### 3.4 Instrumentation and Control

STD DEP T1 3.4-1 (Figure 3.4a, Figure 3.4b, Figure 3.4c)

**Figure 3.4a Safety System Logic and Control (SSLC) Control Interface Diagram**

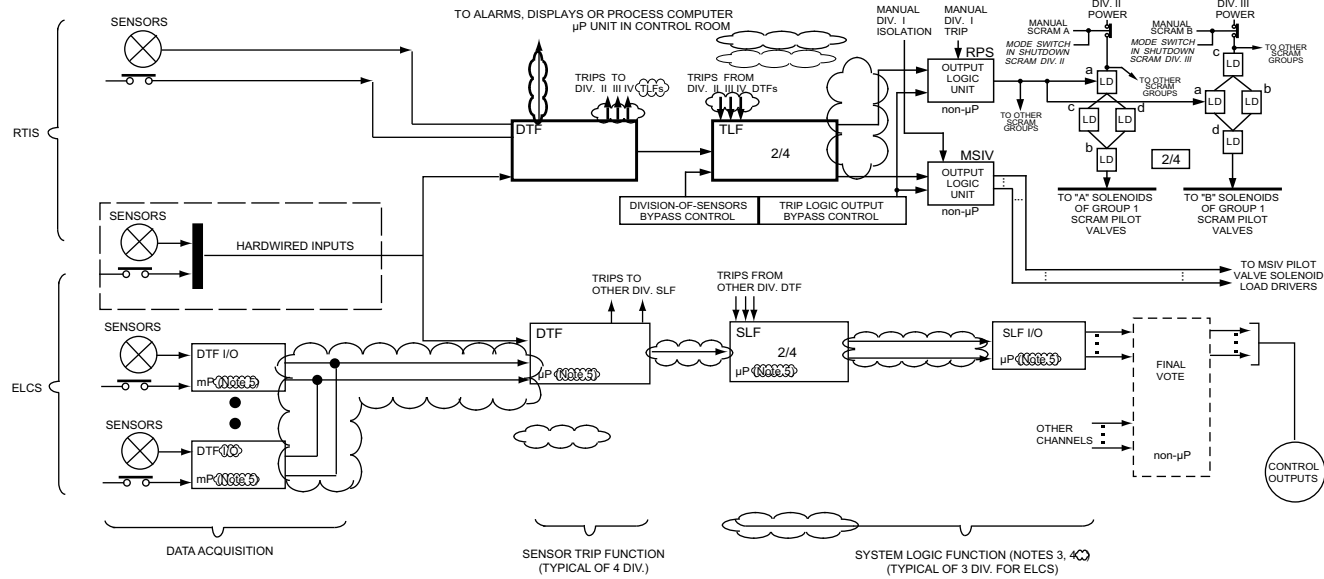
safety-related portions of the Neutron Monitoring System (NMS), the Containment Atmospheric Monitoring System (CAMS) and the radiation monitoring systems. The relationship between SSLC and systems for plant protection is shown in Figure 3.4a.

**Figure 3.4b Safety System Logic & Control Block Diagram**

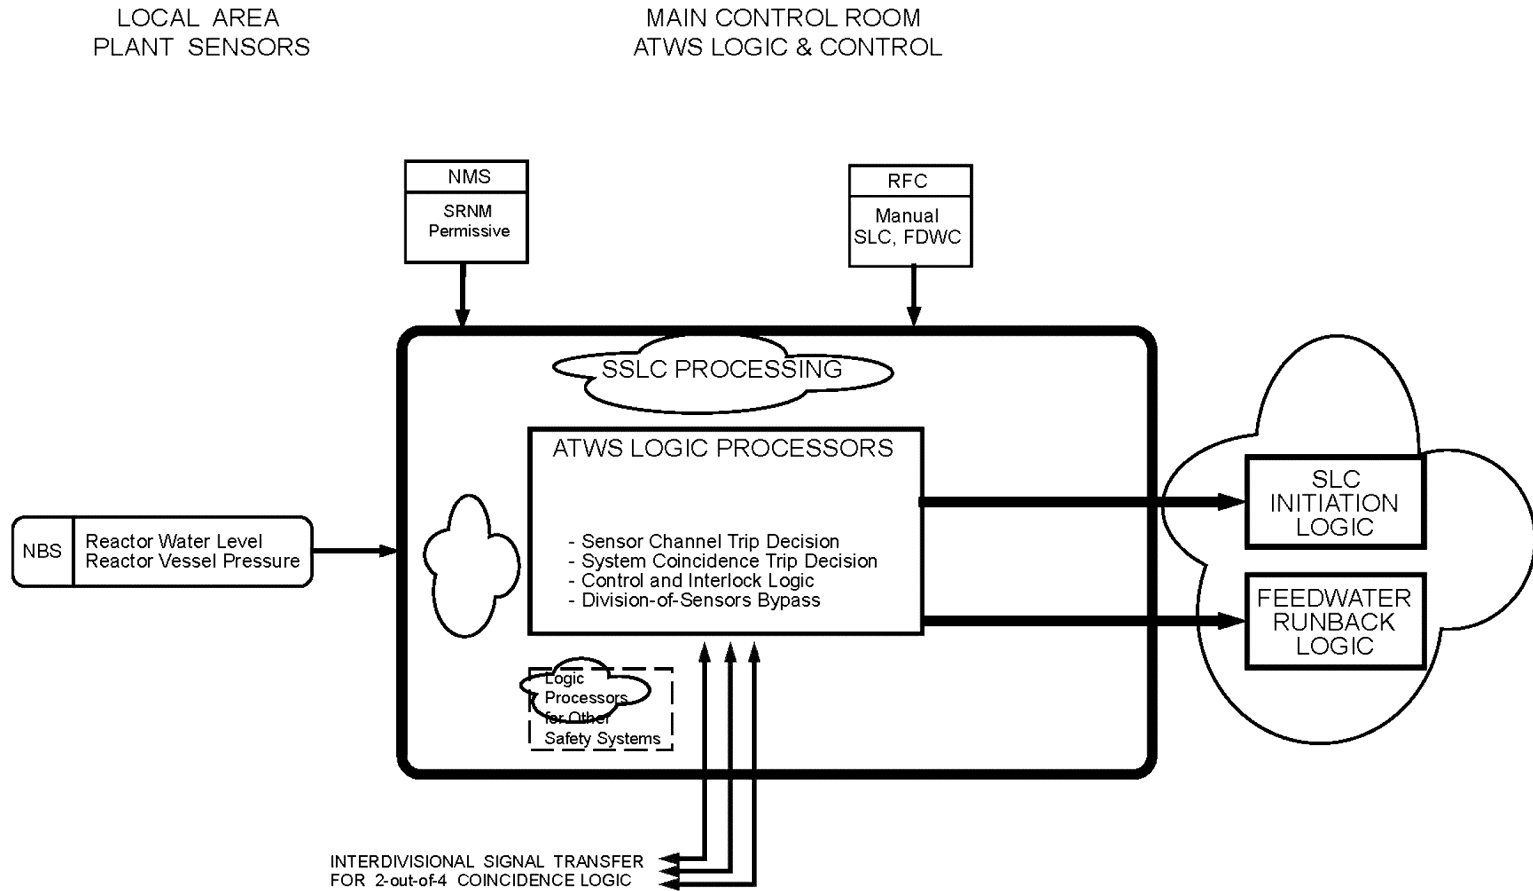
~~The basic hardware functional configuration for one division of SSLC is shown in Figure 3.4b. Each division runs independently (i.e., asynchronously) with respect to the other divisions. The following steps describe the processing sequence and associated function descriptions for incoming sensor signals and outgoing control signals. These steps are performed simultaneously and independently in each of the four divisions:~~

~~As shown in Figure 3.4b, a pair of SLU are located in each of two engineered safety feature (ESF) processing channels, ESF1 and ESF2. ESF1 processes initiation logic for functions which service the reactor vessel at low pressure (e.g. RHR), while ESF2 provides the same support for the vessel at high pressure (e.g. Reactor Core Isolation Cooling (RCIC) System and High Pressure Core Flooder (HPCF) System). Associated LDS and ESF functions are also allocated to these logic channels.~~
